Plan Name:	GRADING AND DRAINAGE PLAN
Project:	SULLIVAN SUBDIVISION 8 WHITTAKER DRIVE, STRATHAM, NH 03885
Owner of Record:	ROBIN SULLIVAN 8 WHITTAKER DRIVE, STRATHAM, NH 03885

Hillcrest Drive Issues
Sullivan Subdivision
8 Whittaker Drive, Stratham, NH
JBE Project No. 13070.1
November 16, 2017

Re: Subdivision Plan Review – Sullivan
Tax Map 19, Lot No. 68
112 High Street, Stratham, NH
Our Reference No. 1768

RE: **6-Lot Subdivision Application** to create five (5) new building lots at 8 Whittaker Drive, Stratham NH 03885, Map 19 Lot 68 submitted by Jonathan S. Ring, PE, Jones & Beach Engineers, Inc., PO Box 219, Stratham, NH 03885.

DRAWING No.
P1
SHEET 5 OF 8 JBE PROJECT NO. 13070.1

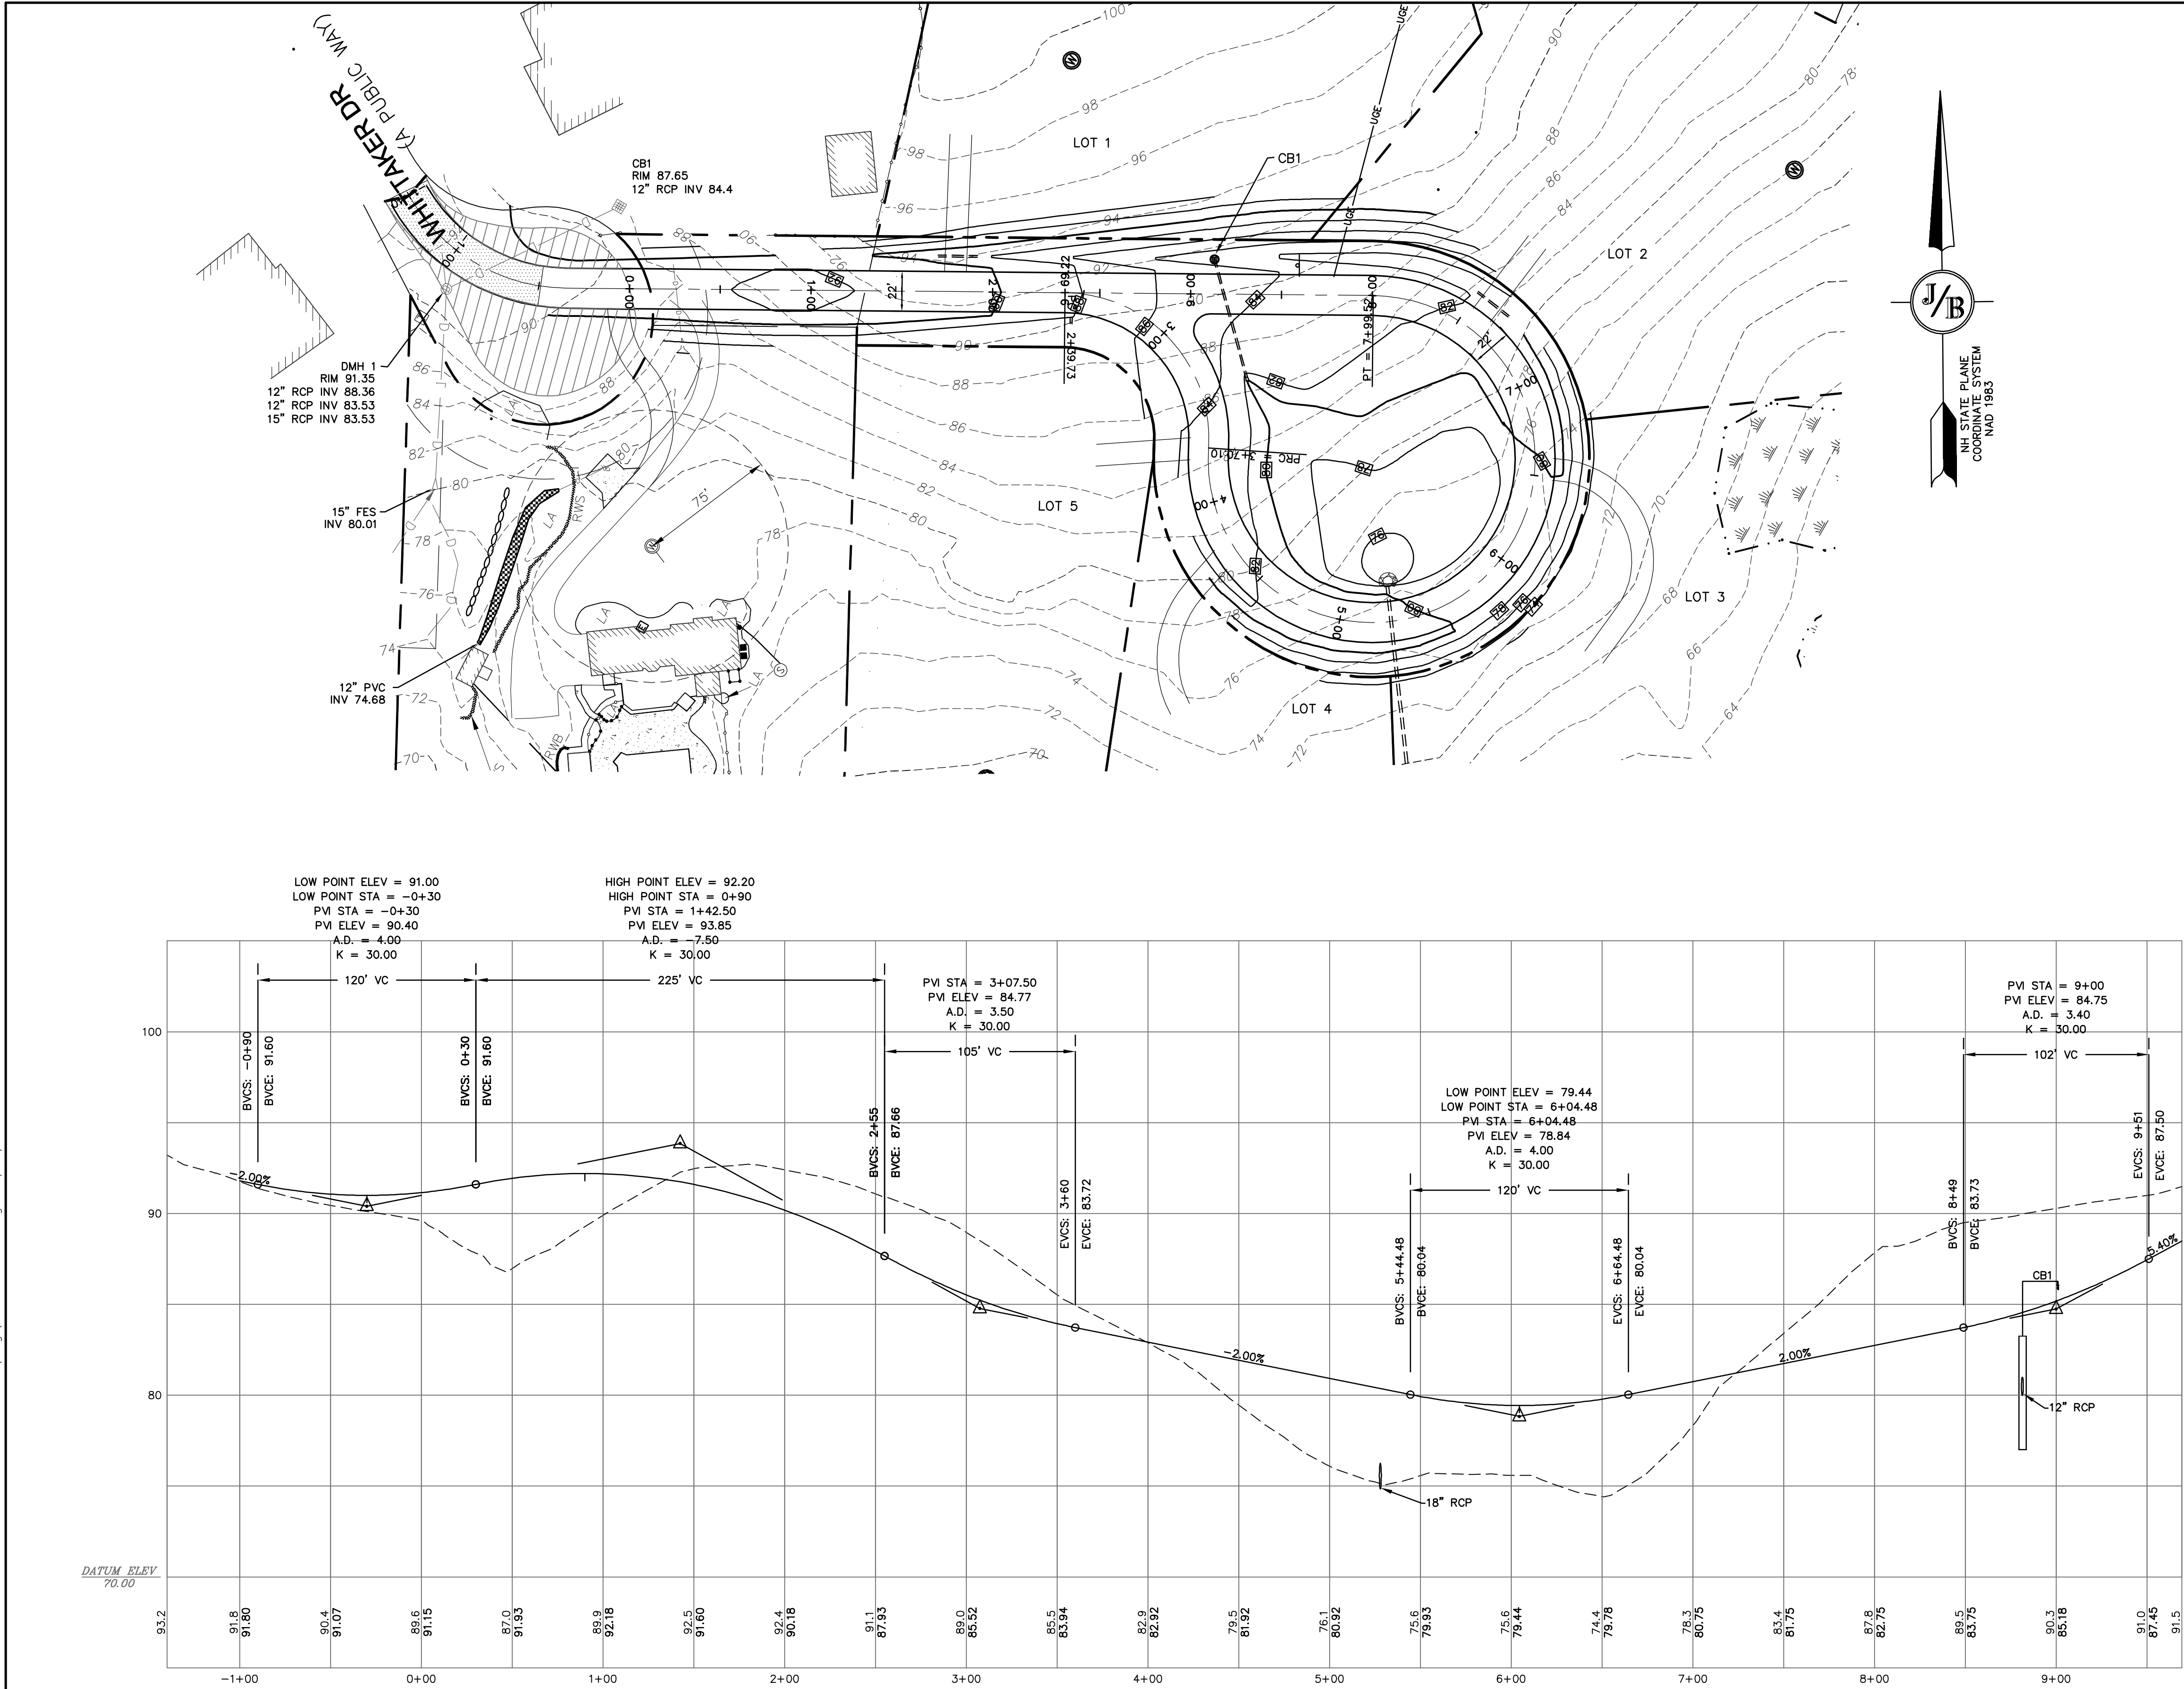
6. The overall length of the proposed cul-de-sac (to its "throat") is over 800'. The maximum length allowed in Section 4.4.3,a.,ii. Is 800'. A WAIVER from the Regulations has been requested to allow for this.
7. We are not certain as to why "most abutters are opposed to through road connection".
8. We do not see where "..... topographical conditions make such (through road) continuance or conformity impractical". JBE has demonstrated on their most recent plans that a through road connection is possible, albeit at some additional cost.
9. Between the proposed "THROUGH" road STA 3+70 and STA 5+50 and also, between STA 9+80 and STA 11+25, the centerline road profile grade is more than 4% on a horizontal curve. A WAIVER from ADDENDUM A, TABLE 1; of the Subdivision Regulations will be required to allow this proposed roadway vertical alignment.

DRAWING No.	CPP3
SHEET 1 OF 2	JBE PROJECT NO. 13070.1

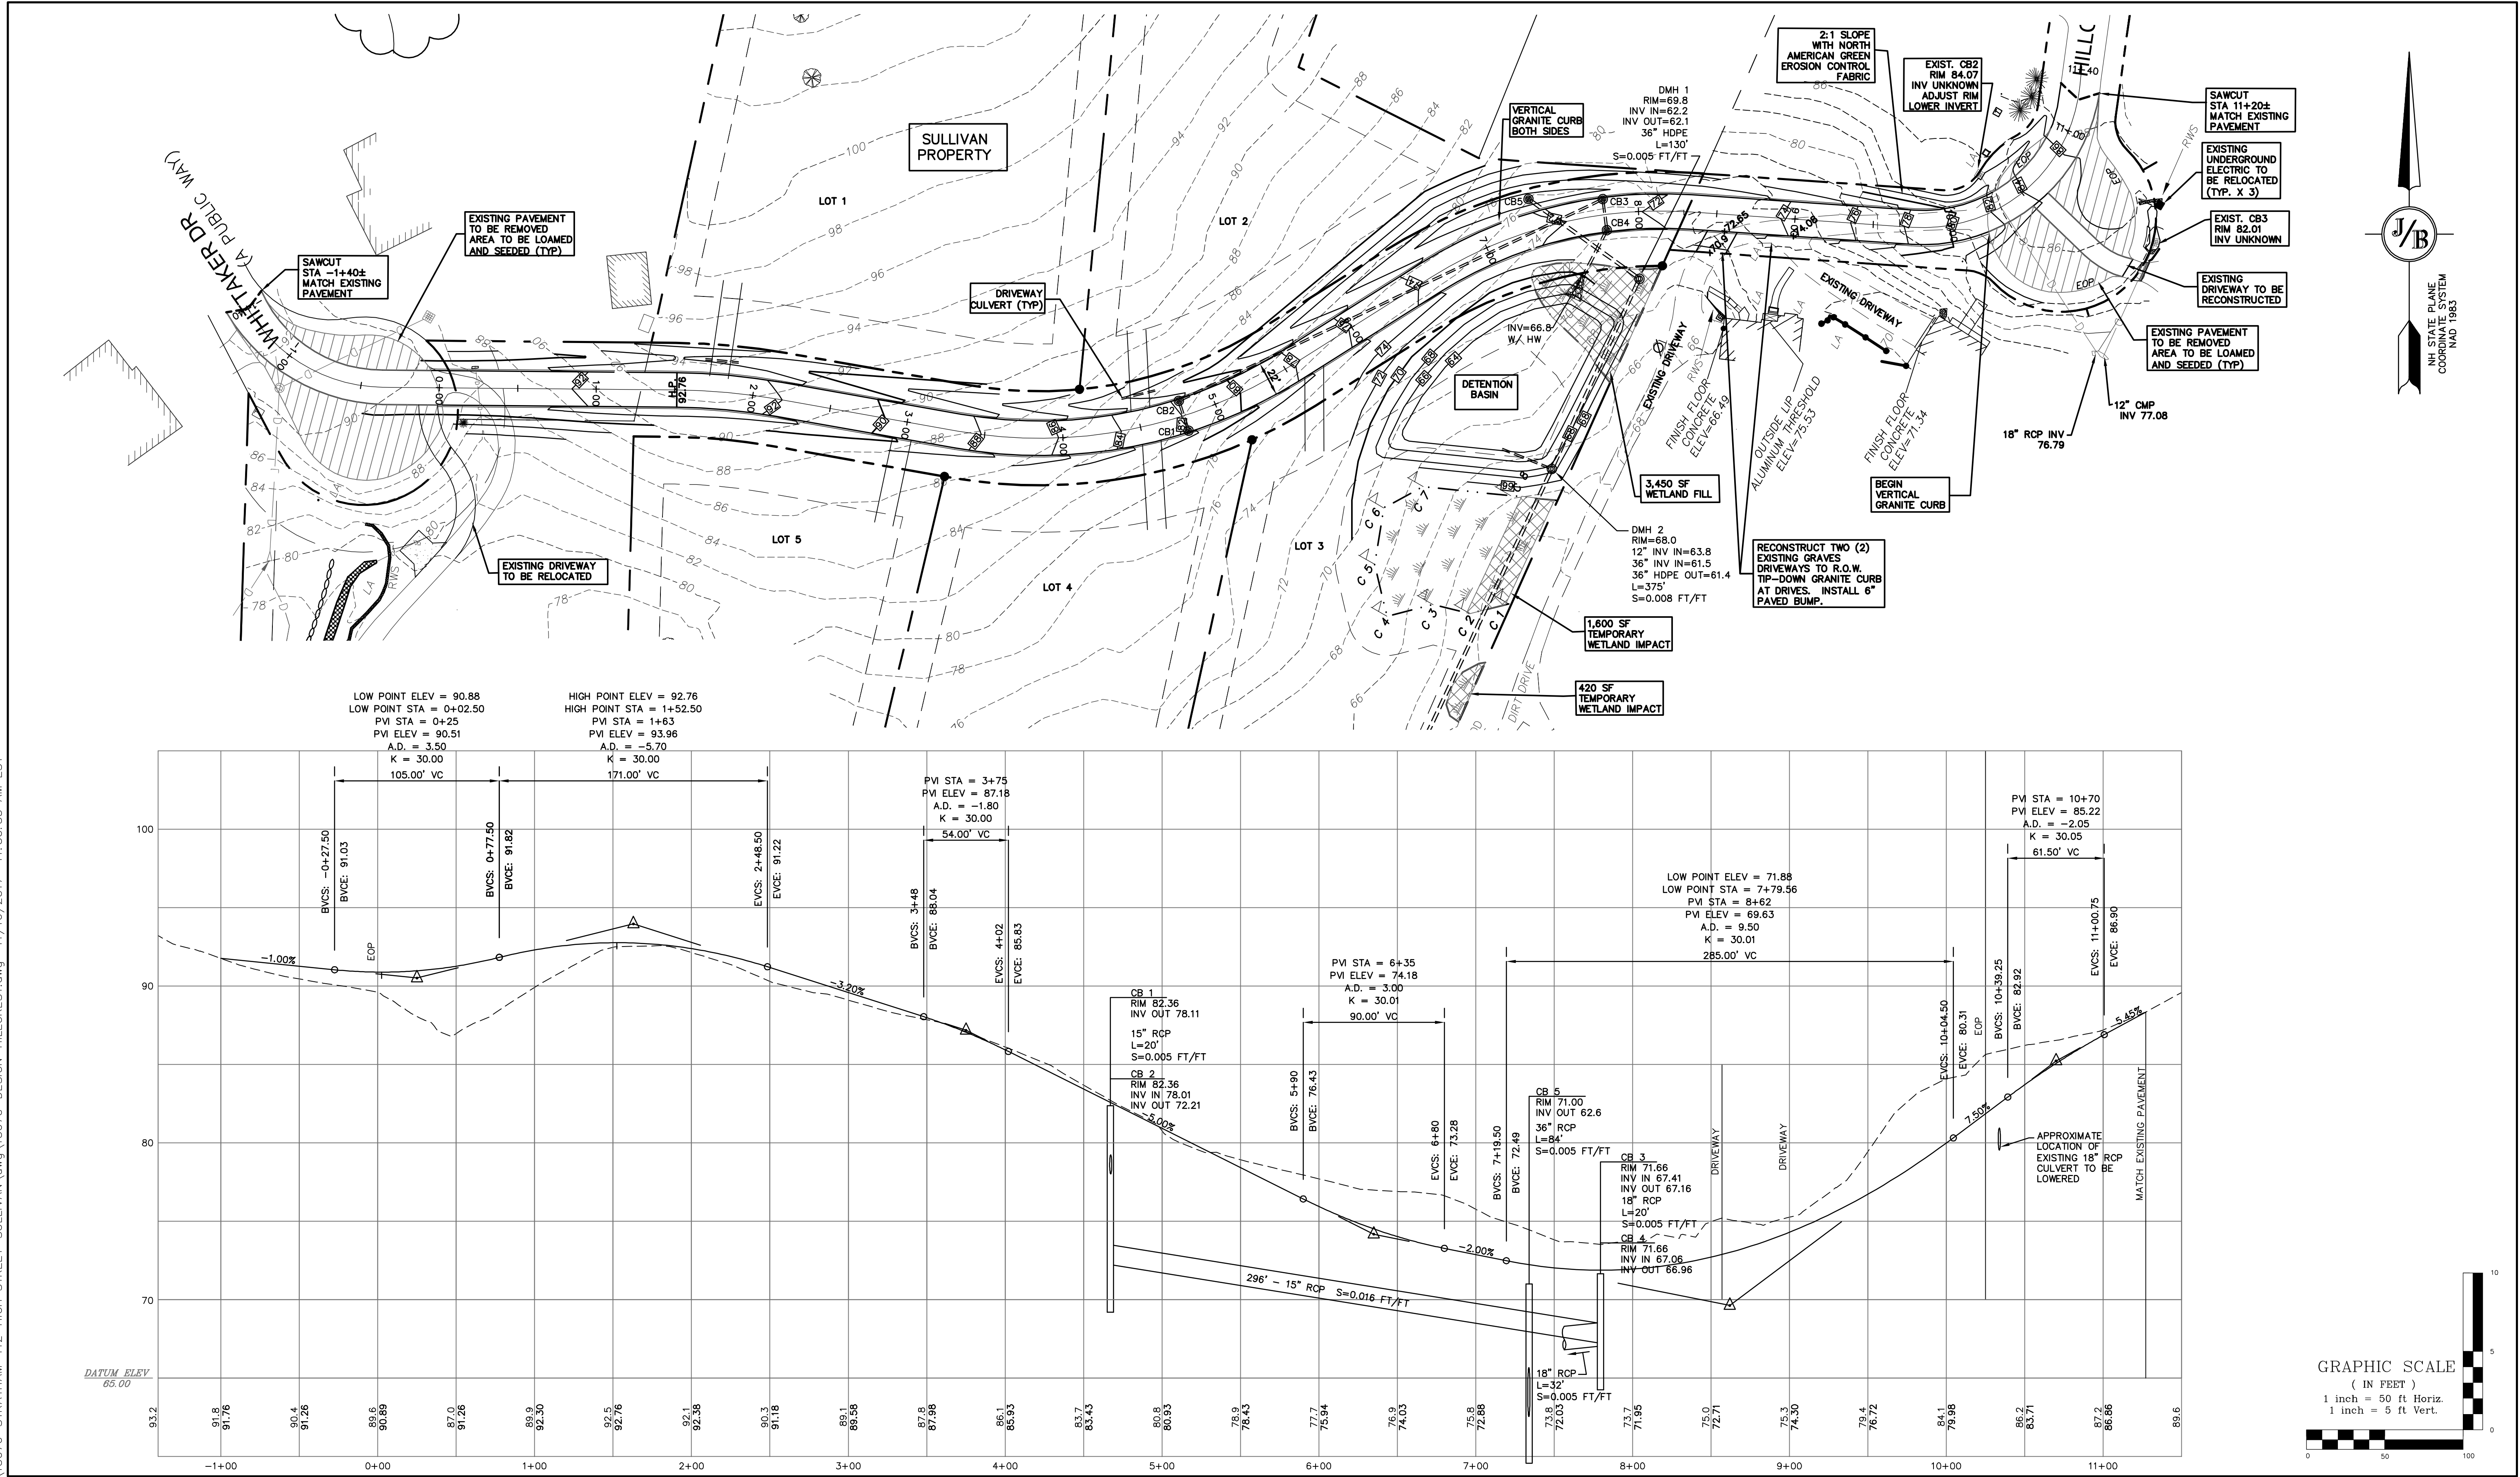
1. Total road length 1,280' vs. 1,110' for Whittaker Drive extension cul-de-sac.
2. 22' wide road for each option.
3. Hillcrest 50' wide R.O.W. is narrow.

4. Relocate 340' of existing underground utilities at Hillcrest cul-de-sac. Exact location unknown, so cost may be higher. (\$10,200)
5. Deepen catch basin and 140' of existing 18" pipe at Hillcrest cul-de-sac. (\$5,060)

6. Reconstruct two (2) driveways to Graves property, plus one abutter. (\$2,663.75)
7. 2' wide shoulder behind vertical granite curb from Station 8+00 to 10+40 left and right.

8. No ditch line Station 8+00 to 10+40 left, so drainage flows directly across 2' shoulder onto pavement.
9. 2:1 Slope from Station 9+00 to 10+40 left.
10. Vertical granite curb to control drainage both sides of road, which requires five (5) catch basins, two drain manholes, and 970' of drainage pipe. (\$111,798)

11. Wetland fill of 5,470 S.F. for road slope, detention pond berm, drainage pipe necessary at low point elevation of through road. (\$3,500 Permit)
12. Preliminary Construction Cost Estimates (see attached):

2. The proposed "THROUGH" road is only 170 L.F. longer than the proposed "CUL-DE-SAC" road.
3. It appears as if a stormwater drainage culvert should be installed under the proposed road at STA 0+50.

4. We are not certain why vertical granite curbing is specified on both sides of the proposed "THROUGH" road between STA 0+00 and STA 7+00. If same were eliminated, CB1 and CB2 along with 316' of 15" RCP storm drain pipe could also be eliminated. Pipe, catch basin, and granite curbing elimination could save approximately \$57,480 in construction costs.

5. We are not certain as to why 340 L.F. of existing underground utilities would have to be relocated at Hillcrest Drive. If they do not require relocation, approximately \$10,200 in construction costs could be saved.
